Attachment 1 - PLN16/0471.01 - 344 Johnston Street Abbotsford - S52 Advertising Plans Part 1

To:	Gary O'Reilly	Date: 11/6/19
Cc:		
From:	Scott W	
File:	PLN16/0471.01	
Subject Site:	344 Johnston Street, Abbotsford	
Subject:	Review of revised document submitted for an amendment to an existing permit

**To:** Gary O'Reilly  
**From:** Mark Pisani  
**Date:** 13 May 2019  
**Subject:** Application No: PLN16/0471.01  
 Description: Section 72 Amendment  
 Site Address: 344 Johnston Street, Abbotsford

**TO:** Gary O'Reilly (Statutory Planning)  
**FROM:** Hayley McNicol (Urban Design)  
**DATE:** 17 May 2018  
**SUBJECT:** 344 Johnston Street Abbotsford  
**APPLICATION NO:** PLN16/0471.01  
**DESCRIPTION:** S72 Amendment to Planning Permit PLN16/0471 to:  
Alter the permit preamble from the use of dwellings (levels 4-6) to offices, including a shop at ground floor (no permit required for uses);

Drawing No. TP10 Revision 12 dated 18 December 2018

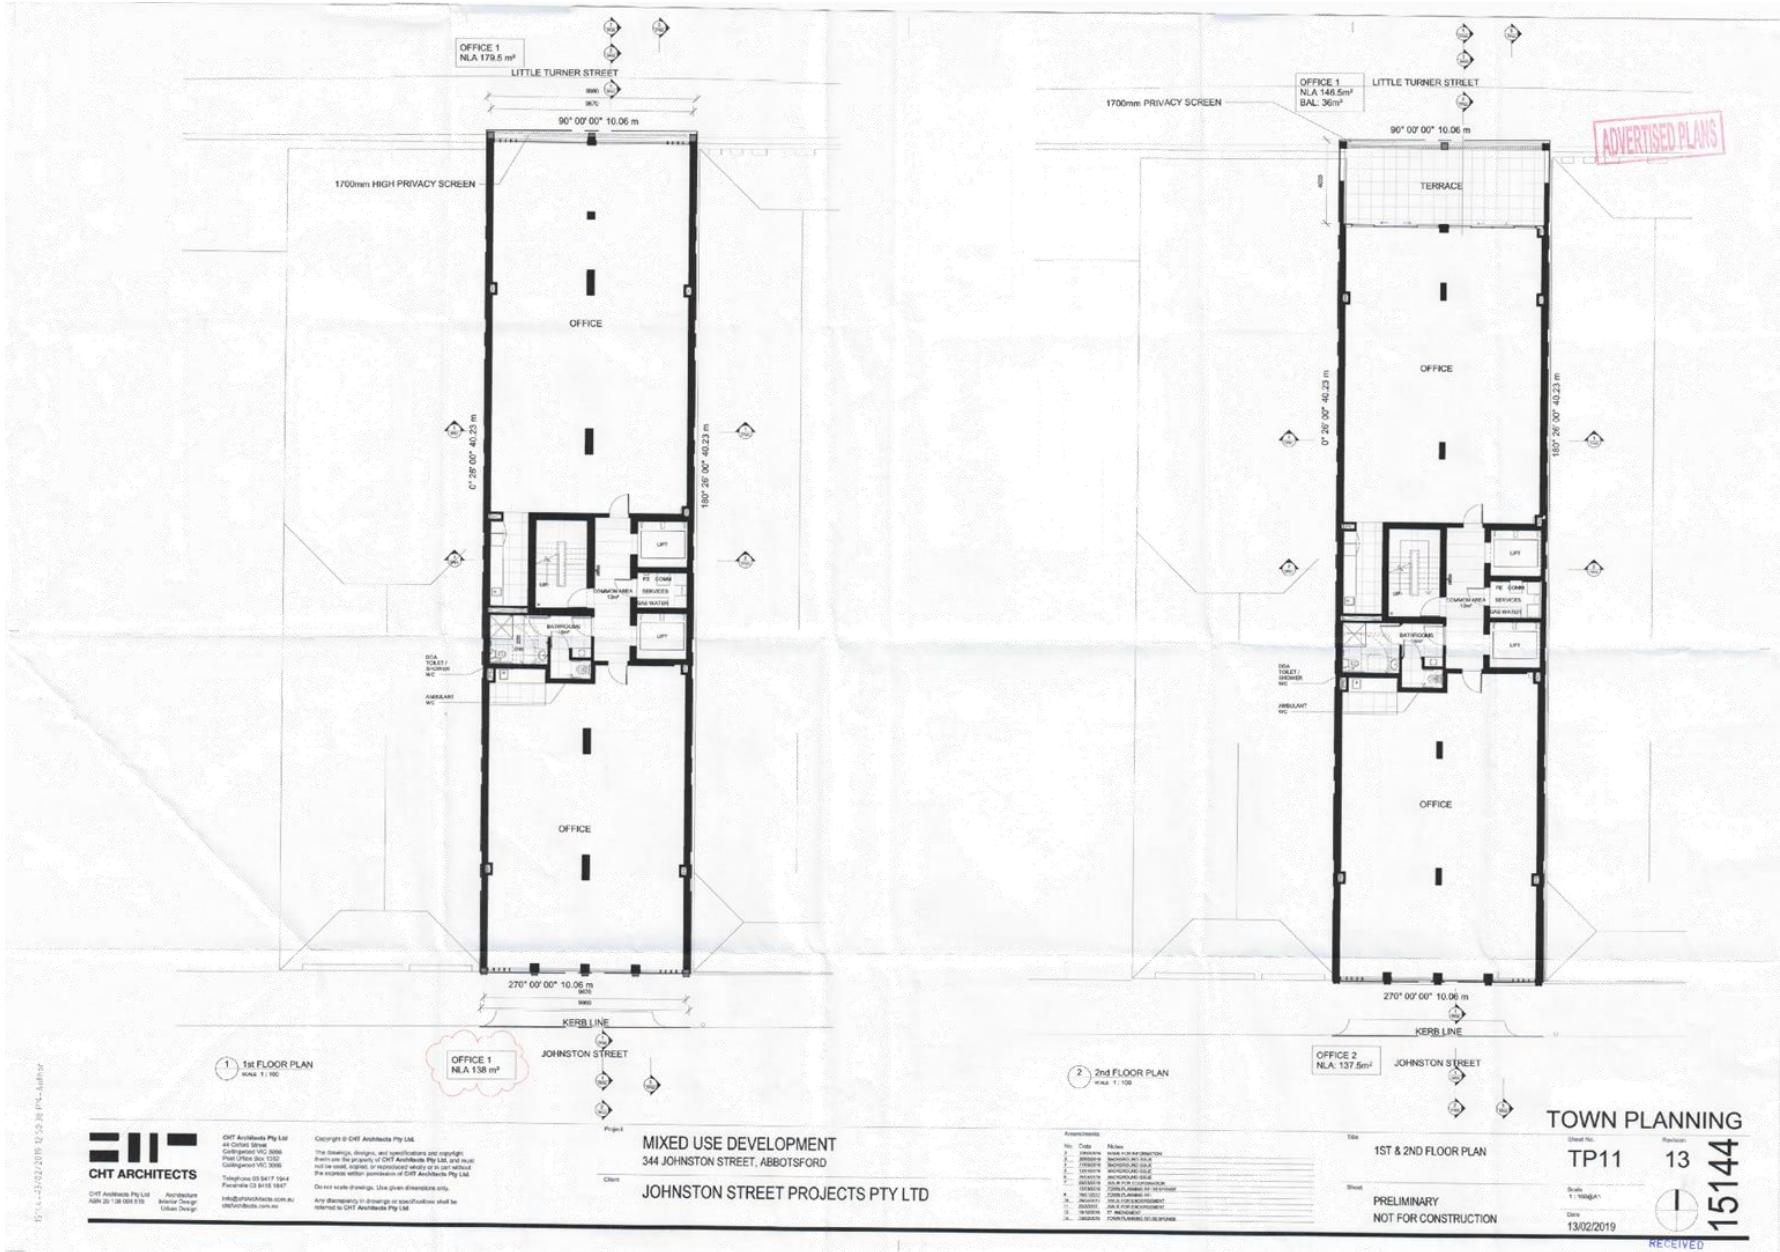
Item	Assessment
<b>Access Arrangements and Mechanical Parking</b>	
Stacker Devices	The parking configuration and layout of the stackers and access arrangements are consistent with the endorsed drawings (dated 1 June 2017). The stacker platforms in the amended proposal retain the same platform widths, whereas the platform lengths have slightly increased. The proposed access and parking layout of the amended proposal are considered satisfactory.

Clarification is required regarding the total number of employee bicycle spaces proposed. The Ground Floor Plan specifies 14 wall rack spaces and 4 horizontal spaces, however the Traffic Impact Assessment prepared by Traffix Group outlines differing information: page 15 notes a total of 11 bicycle parking spaces and page 14 notes a total of 18 bicycle parking spaces.

The 7 wall racks shown on the Ground Floor Plan indicate these spaces are to be double-sided (2 bike) spaces as the plan notes 14 spaces will be provided as wall racks. Typically the Ned Kelly bike racks only hold a single bike.

If the applicant is planning to use a storage device which allows for double-sided hanging, a minimum 800mm clearance is required between racks. Otherwise, if it is proposed to provide 7 spaces as wall racks and 4 spaces as horizontal racks, an additional 5 spaces will be required to meet Council's Best Practice rate (16 spaces<sup>2</sup>).

**TOWN PLANNING**  
 Sheet No. TP42  
 Revision 12  
 Date 18/12/2018  
 Status: PRELIMINARY  
 NOT FOR CONSTRUCTION

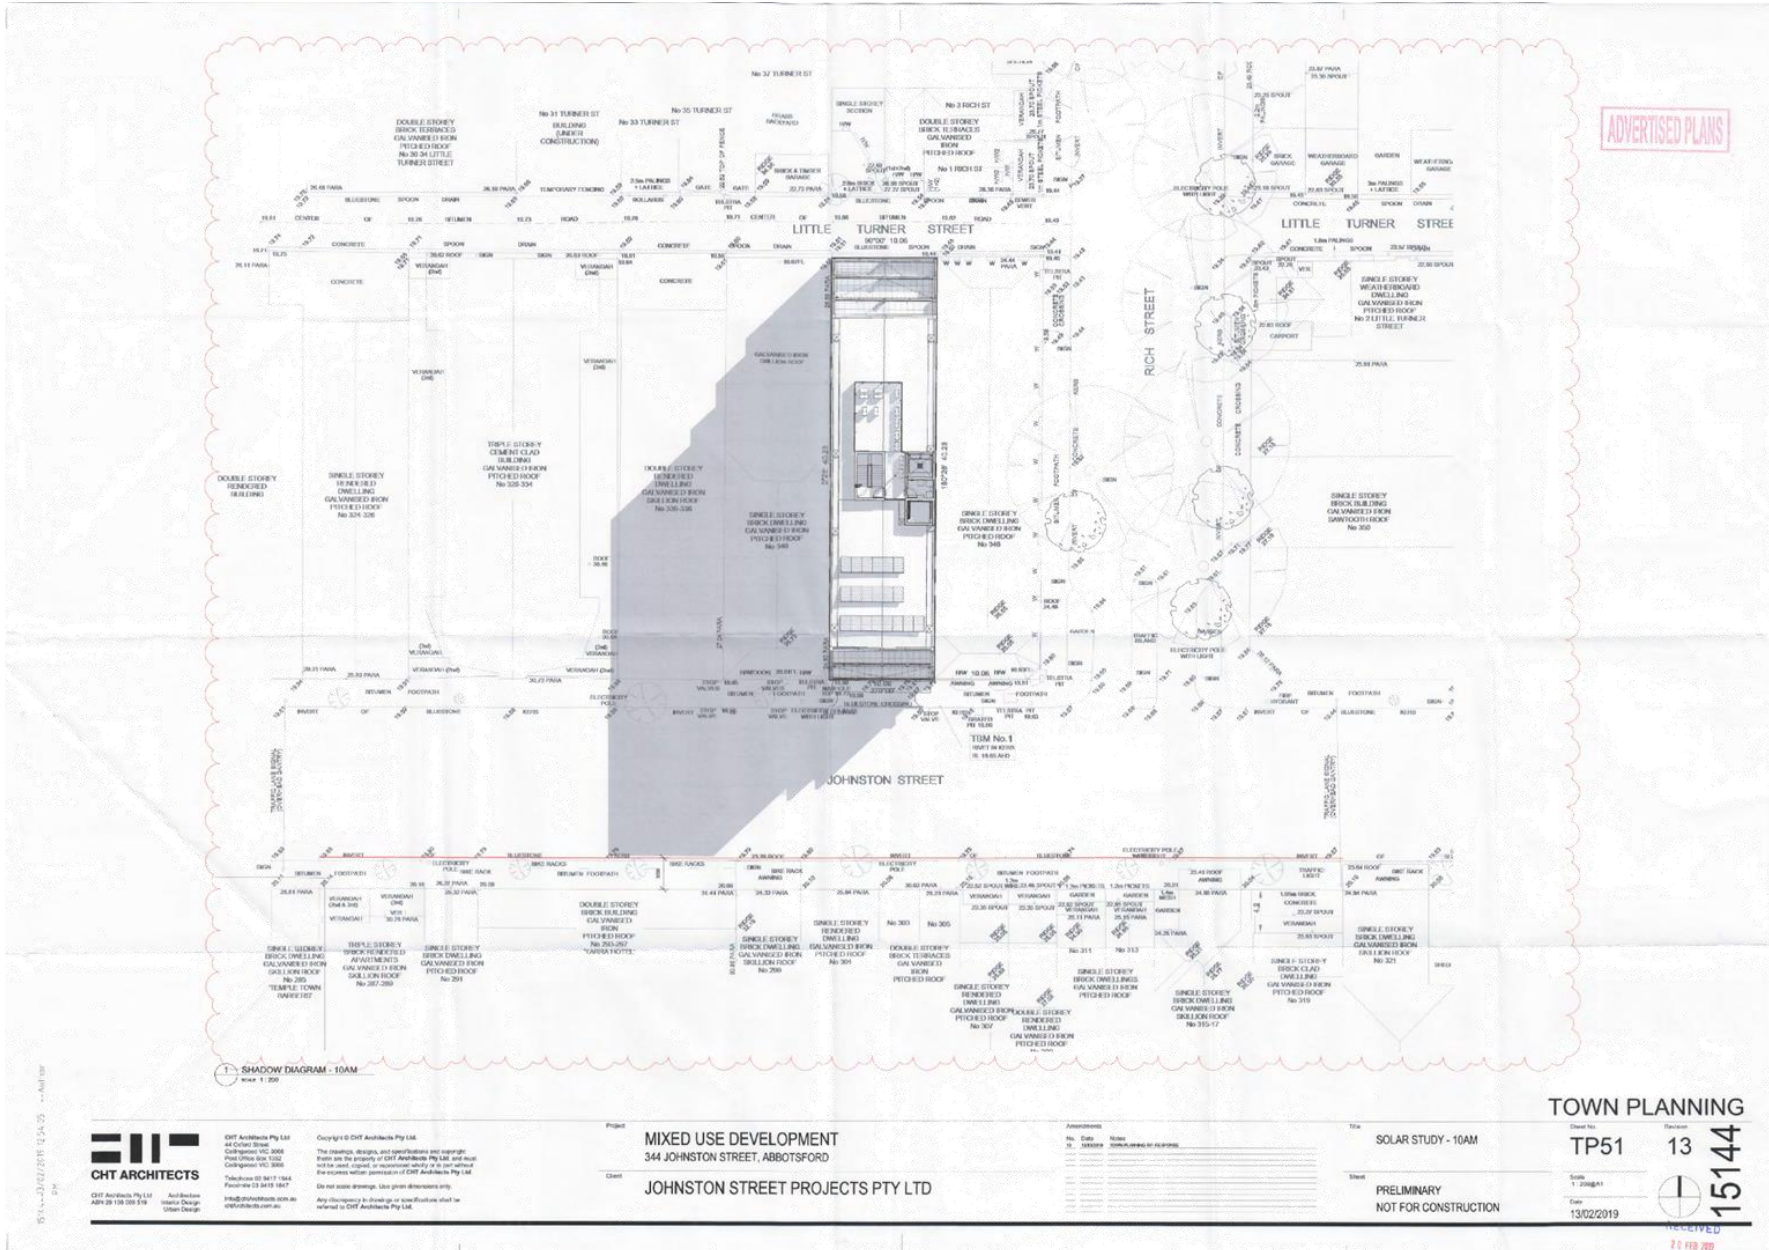
- Change the glass balustrades at Levels 04-06 facing Little Turner Street to be consistent with Levels 02 and 03.
  - Review materials along the eastern and western shear walls to provide a more textured appearance.

- The south facing balconies at Levels 05 and 06 have been removed. The previous scheme with balconies is preferred as it provided a more consistent upper level treatment, as well as reducing the dominance of the upper levels as mentioned above.
- The rear balustrades have been changed to glass. The glass balustrades are discouraged as they would make the balconies appear more cluttered, as everything stored within the balcony space can be viewed from the street. Furthermore the windows can be difficult to clean and maintain. It is suggested to change the balcony treatments to be consistent with BAL02 on Levels 02 and 03.

**Section through Northern façade**

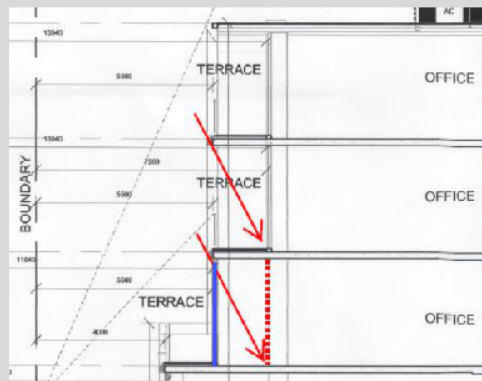
- Reduction in terrace size and reduced setback to Little Turner Street (Level 4)
  - *Not supported – The current approved terrace depth gives good sun-protection of this full-height northern glazing, and moving the wall outward would leave it unprotected from summer sun, decrease thermal comfort and increase peak energy demand (see image below).*

- Existing Level 4 terrace depth provides protection from northern summer sun (red dashed line)
- Moving this wall outward would result in unshaded glazing and high solar-heat loads (blue line)
